**BEFORE THE OFFICE OF ENERGY INFRASTRUCTURE SAFETY
OF THE STATE OF CALIFORNIA**

**OPENING COMMENTS OF THE UTILITY REFORM NETWORK
ON PACIFIC GAS AND ELECTRIC COMPANY'S
2023-2025 WILDFIRE MITIGATION PLAN**

May 26, 2023

Figure 1. Average Wildfire Risk Score of Top 1,000 Circuit Segments⁴⁷

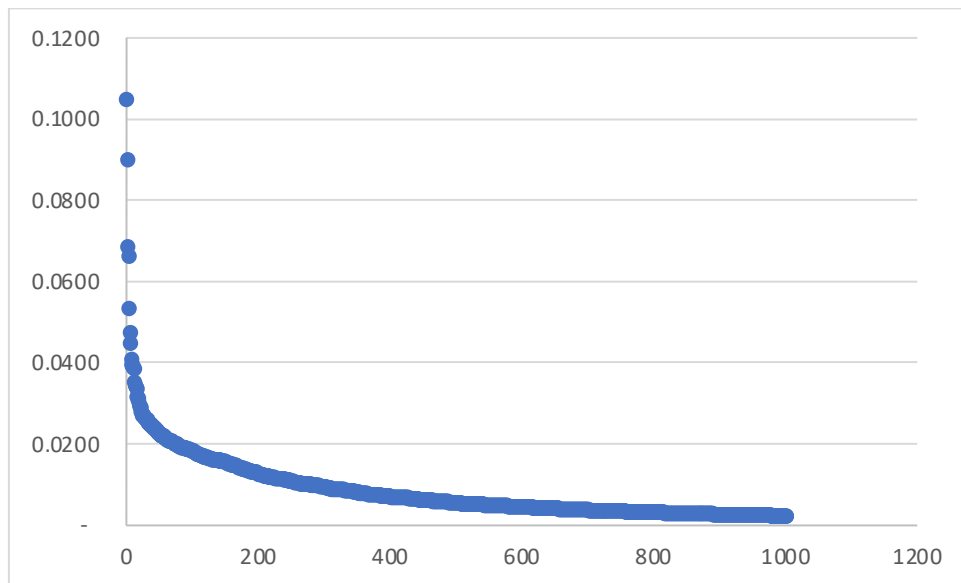
PG&E’s definition of “high risk” is based on a *count of circuit segments* modeled, in which the total number of circuit segments modeled in the utility’s HFTD is multiplied by 20% to find the threshold of “top 20 percent.”⁴⁵ This methodology would be equivalent to wildfire risk if each circuit segment had the same amount of risk. However, wildfire risk across circuit segments is highly heterogeneous. The figure below shows average risk per segment, which PG&E uses to rank and prioritize circuit segments.⁴⁶ The difference between relatively high and low risk circuits varies dramatically.

- The **top 125 circuit segments** represent the highest 20% of wildfire risk in PG&E’s service territory according to PG&E’s modeling results rather than **the top 720** under PG&E’s methodology.
- PG&E’s methodology allows it to prioritize circuits for undergrounding anywhere in the top **80% of wildfire risk**, not the top 20%.
- PG&E has scoped just **437 of 1,802 total miles** in the top 20% of wildfire risk from 2023-2025. This means *at least* 76% of planned miles will not be accomplished in the top 20% of wildfire risk.

**Figure 2. Proposed Non High Risk Miles vs. Total
2023-2025⁵⁵**

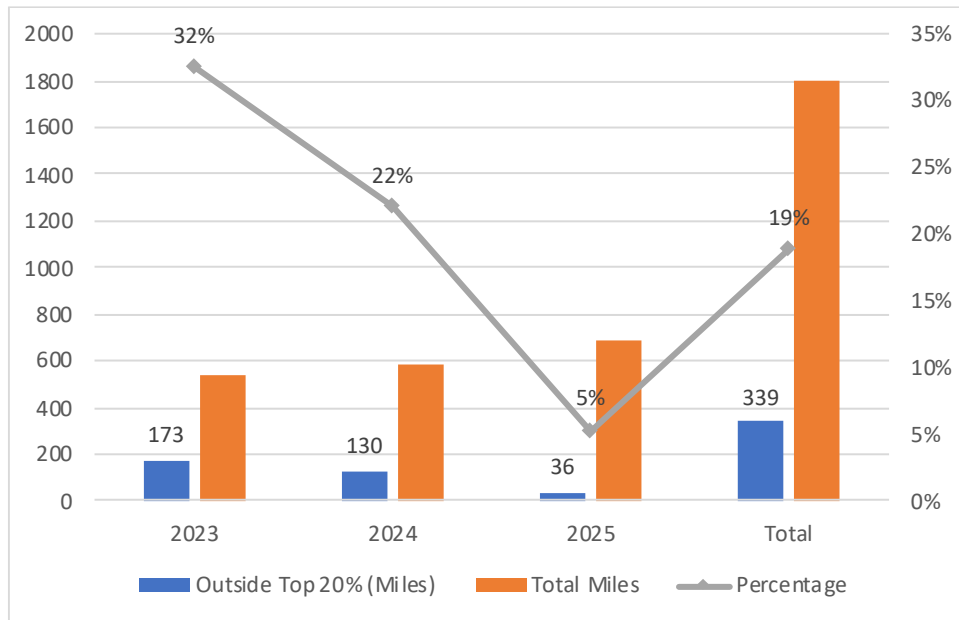
To the extent that undergrounding is deployed, the tremendous costs and resources of this mitigation should be focused on the very highest risk areas. For example, the 339 miles shown above would cost ratepayers about \$1.2 billion, despite mitigating very little risk. We understand that many (68%) of these non high-risk miles are for “fire rebuilds,” *i.e.*, infrastructure that must be rebuilt in the aftermath of a catastrophic wildfire.⁵⁶ Still, this highlights PG&E’s approach to undergrounding as its default solution, rather than focusing on mitigating the most possible risk within reasonable resource and cost constraints.

**Figure 3. Risk Reduction from Covered Conductor vs. Undergrounding
TURN vs. PG&E, 63% Mitigation Effectiveness for CC**

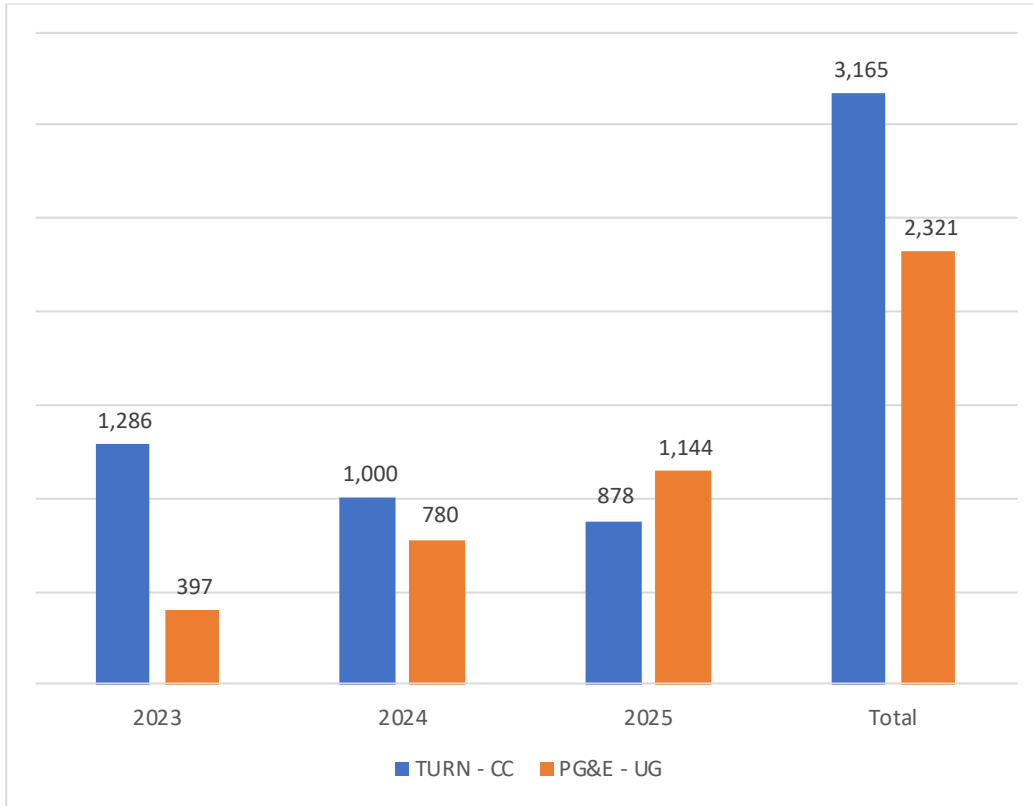
While PG&E’s undergrounding proposal mitigates 10% of wildfire risk through undergrounding, TURN’s corresponds to a 14% reduction.⁵⁸ And ratepayers would spend about \$2.3 billion less on a covered conductor focused approach than undergrounding.⁵⁹

**Figure 4. Risk Reduction from Covered Conductor vs. Undergrounding
TURN vs. PG&E, 90% Mitigation Effectiveness for CC**

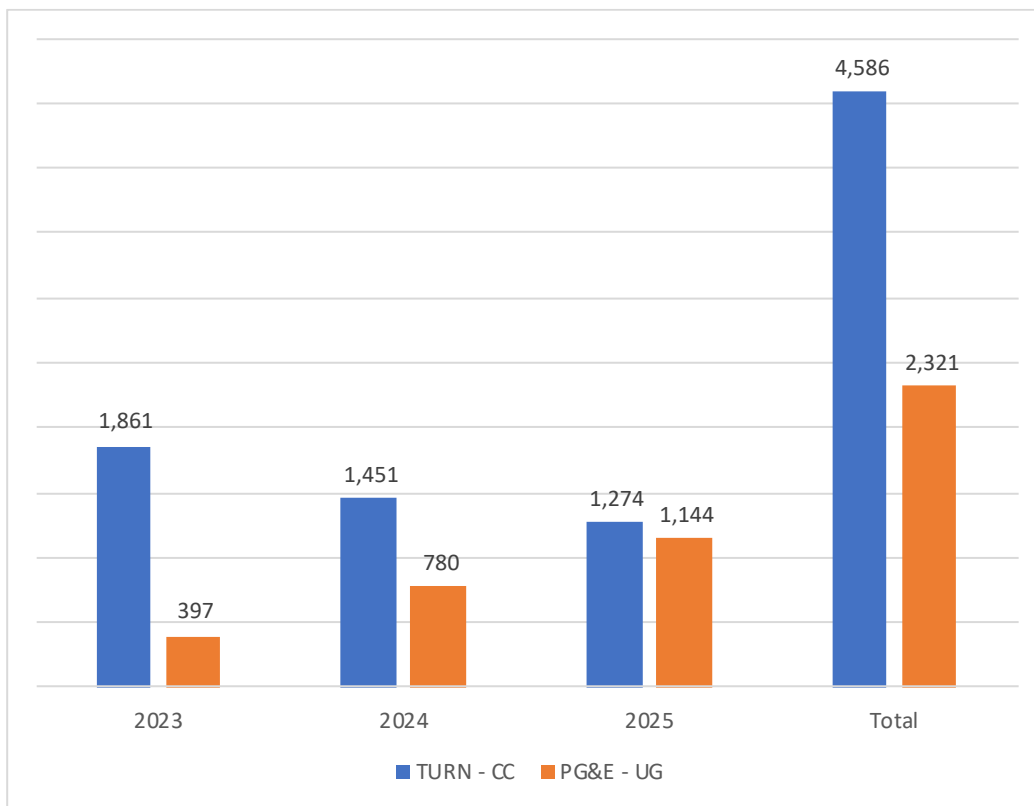
significantly increase risk reduction through covered conductor deployment. The figure below shows that, at 90% effectiveness, covered conductor, if deployed from highest to lowest risk circuits, would achieve nearly double the risk reduction of PG&E’s undergrounding program, in total mitigating 20% of wildfire risk.

Figure 5. Risk Spend Efficiency of Overhead vs. Underground – Tranche Level

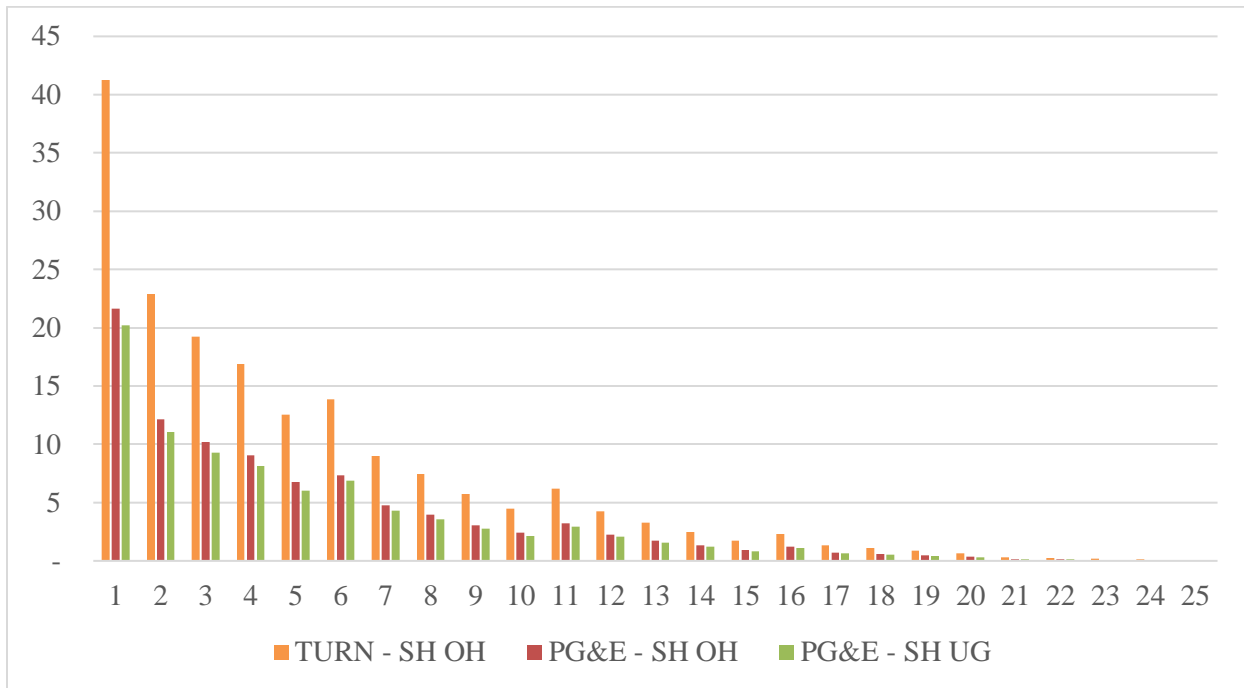
This RSE comparison – and the uniformity of the advantage for covered conductor across tranches -- shows that, if PG&E were to do the project-specific RSE comparison of system hardening alternatives, as directed in ACI 22-34, covered conductor can be expected to have a higher RSE for most projects.

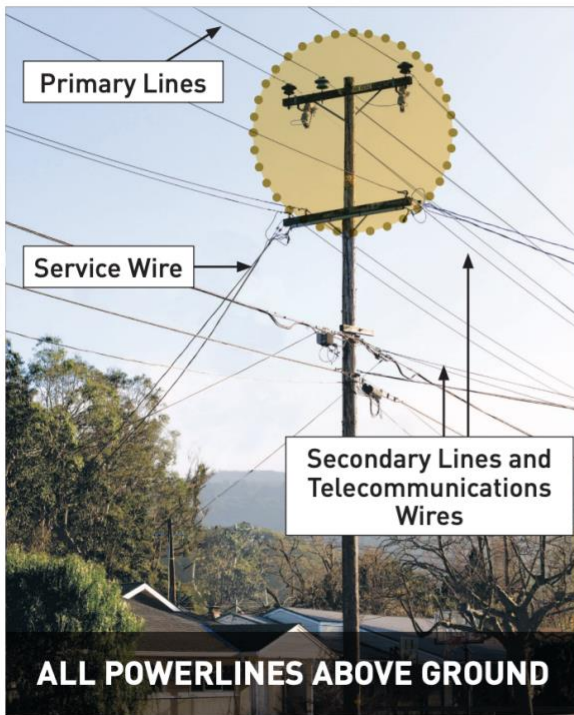
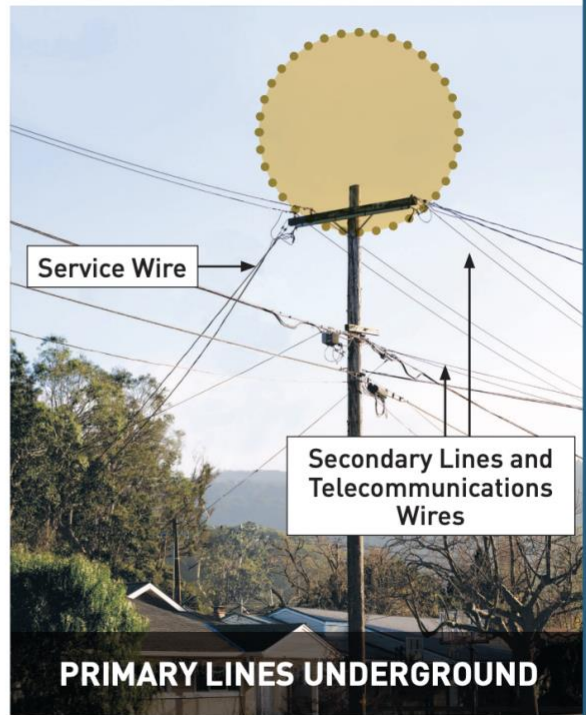
Before and after undergrounding pictures from PG&E's website⁷¹ show that undergrounding will not have the impact that many people may hope for and expect from an aesthetic perspective.

Residents who expect undergrounding to remove visually unappealing wires and poles will be sorely disappointed. In fact, for most people, it will be difficult to see any difference at all.
